UNITED STATES PATENT AND TRADEMARK OFFICE

APPLICATION NO.	FILING DATE	FIRST NAMED INVENTOR	ATTORNEY DOCKET NO.	CONFIRMATION NO.
10/759,102	01/20/2004	Kazuya Miwa	101175-00045	6932

Office Action Summary	Application No.	Applicant(s)	
	10/759,102	MIWA, KAZUYA	
	Examiner	Art Unit	
	Raymond Alejandro	1795

DETAILED ACTION

FIG. 6

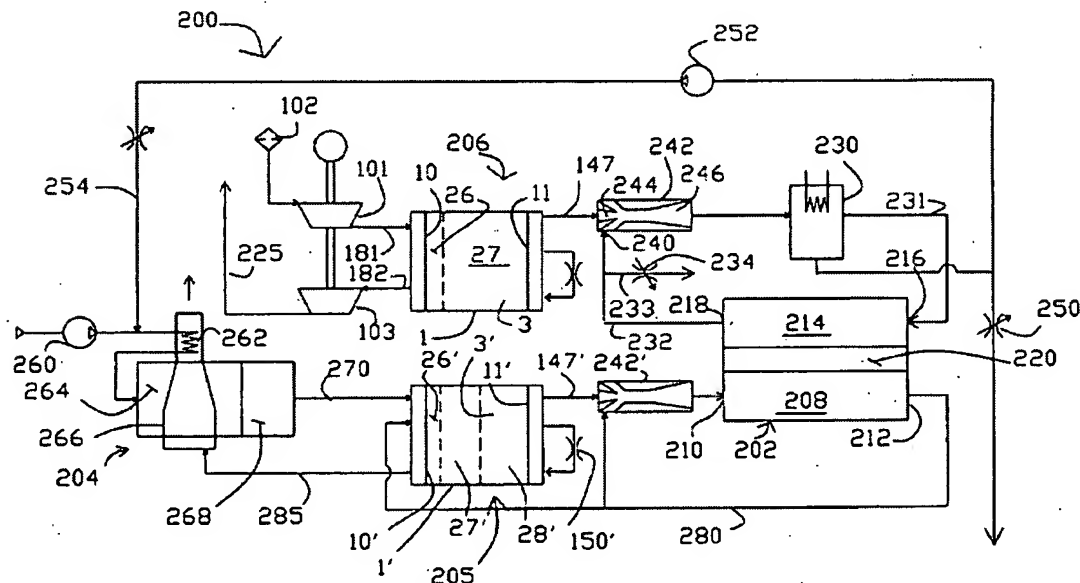
(P0096/CLAIM 18). Reforming is used to generate hydrogen (P0004, 0103), and the fuel cell provides a source of electrical current (P0003). It is evident from **Figure 6** below that the hydrogen purification PSA system 205 is both upstream and downstream of the fuel cell 202 (See FIGURE 6). *Thus, it also receives the anode exhaust of the fuel cell.* **FIGURES 7-9** also depict other fuel cell power plant systems. Keefer et al disclose substitution or combined use of any type of hydrogen purification unit such as gas separation devices including other types of adsorption modules or gas membrane separation systems (P0095 & 0005).

(*Emphasis added*→) From FIGURE 6, it can appreciated that "exhaust gas" in line 280 only comes from the fuel cell (See FIGURE 6) as instantly claimed.

FIG. 6

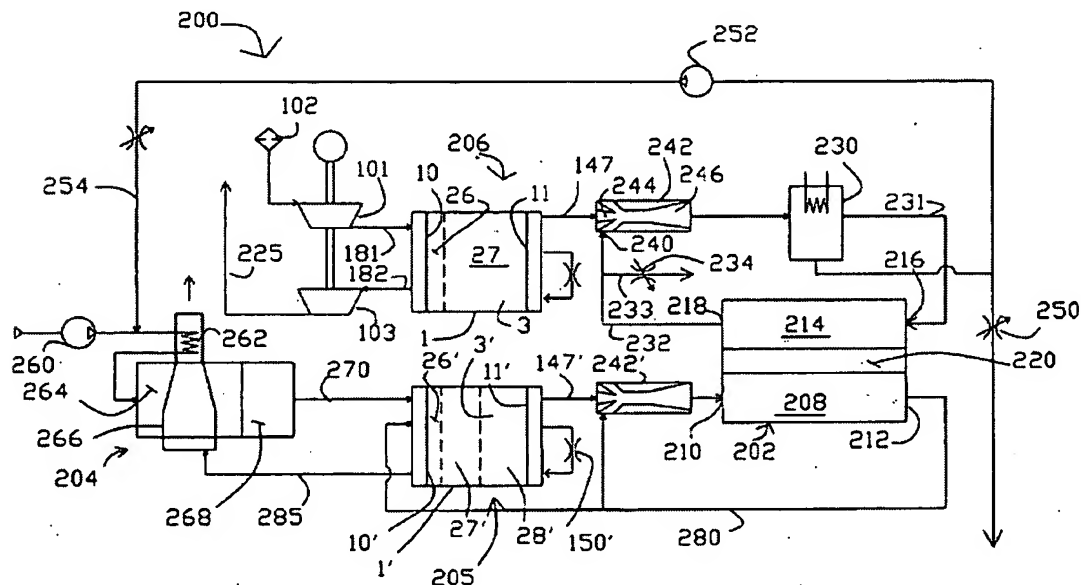
13. Applicant's critical assertion to traverse the above ground(s) of rejection is based upon the contention that the prior art of record does not show the limitation "*wherein the exhaust gas is discharged only from the fuel cell*". The examiner largely disagrees with applicant's assertion. (*Emphasis added*→) From **FIGURE 6**, it can be appreciated that "exhaust gas" in line 280 only comes from the fuel cell as instantly claimed. Hence, Keefer et al's 680 purification PSA system 205 receives the exhaust gas containing hydrogen through line 280 which is discharged only from the fuel cell as instantly claimed (See FIGURE 6).

Therefore, the Examiner sees no differences between the teachings and embodiment of Keefer et al'680 and applicant's invention within the context of the claimed language.
